HEPI Update Nov. 2013

Brian Lantz, Hugo Paris, Charles Celerier, and the Seismic Team
T1300936-v1, Nov. 14, 2013

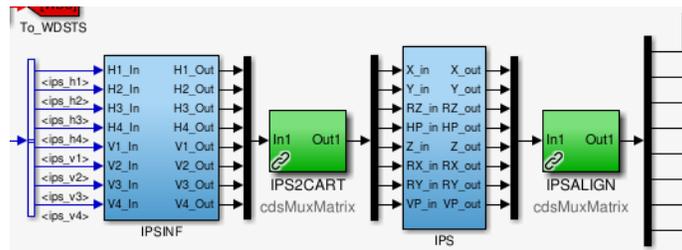
We have implemented the calibrated cartesian monitoring and biasing which was developed for the ISI, and described in detail in [T1300559](#). The simulink diagram has been modified to remove the bias which was at the input to the blend filters, and add it immediately after the IPS2CART matrix, as shown below in figure 2. The local biases for the IPSINF Input Filters should now always be set to 0 and turned off.

We have also implemented a new alignment matrix called IPSALIGN which is used to minimize HEPI rotations when HEPI is translating. This serves exactly the same function as the CPSALIGN matrix in the ISI. Initially, this 8x8 matrix will be the identity matrix. We have found that small off-axis terms can be used to dramatically reduce the tilt of the HEPI system, for example see [LHO alog entry 8291](#). As with the ISI, this matrix is placed directly after the cartesian basis monitor and bias block, as can be seen in figure 2.

Figure 1: The location of the new cartesian basis bias block is just after the IPS2CART basis change. It is named IPS, which was chosen to give reasonable epic value names such as H1:HPI-HAM2_IPS_X_LOCATIONMON. The new IPSALIGN matrix follows the monitoring to be sure the monitors are watching just the sensors, and not the user defined cross coupling.

Figure 3: Revised contents of the ISO block

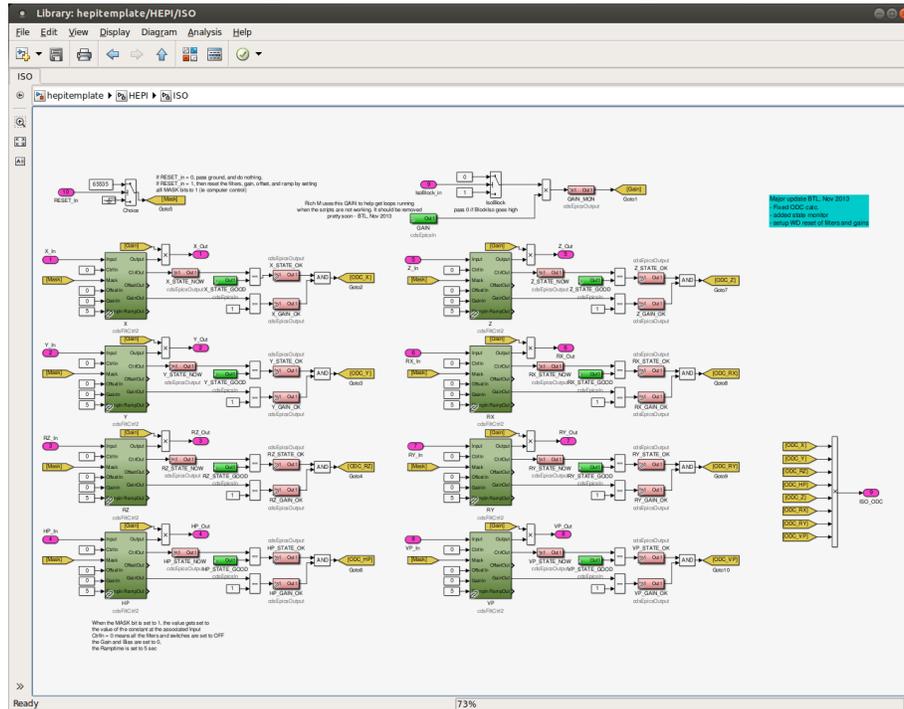
The isolation control filters are all in the ISO block. ISO block has been updated considerably. The isolation loops per-se have not been modified, but new automation and monitoring have been added. The output of the isolation filters can now be blocked im-

diately by the IsoBlock input from the Watchdog, via the GAIN goto/from tag, which will be true when the watchdog state is 2, 3, or 4. When the Watchdog state is 2, the IsoReset input will set all the filter modules to 'all off, ramp time of 5 seconds' so that when the watchdog is reset the loops will not instantly reengage with whatever large offsets then happen to have. The ODC now watches the gain and filter settings for each module, and it 'ands' the results together in the same way as is done for the ISI models.

Figure 5: IPS watchdog block showing the new cumulative counting feature.

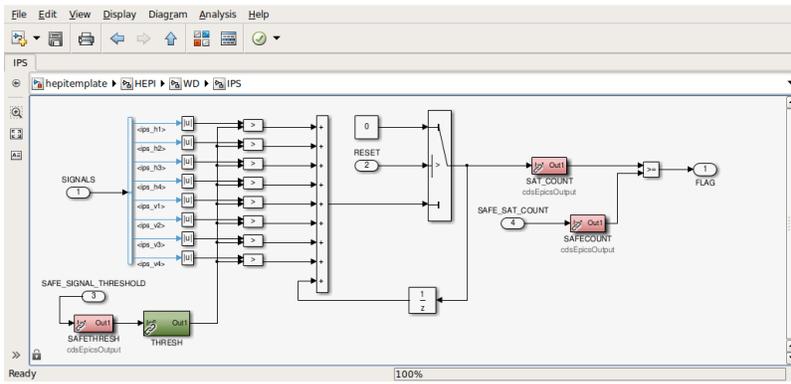
We have updated the model to allow the watchdog to 'ride-through' 10 clock cycles with saturations before tripping (about 5 msec). The IPS block with the counting is shown below in figure 5. This is cumulative for each sensor set. e.g. if the IPS gets funny glitch which saturated the sensor for 1 count, and this happens twice per day, the watchdog will not trip for the first 5 days. An indicator is shown to the operator, and can be reset by the
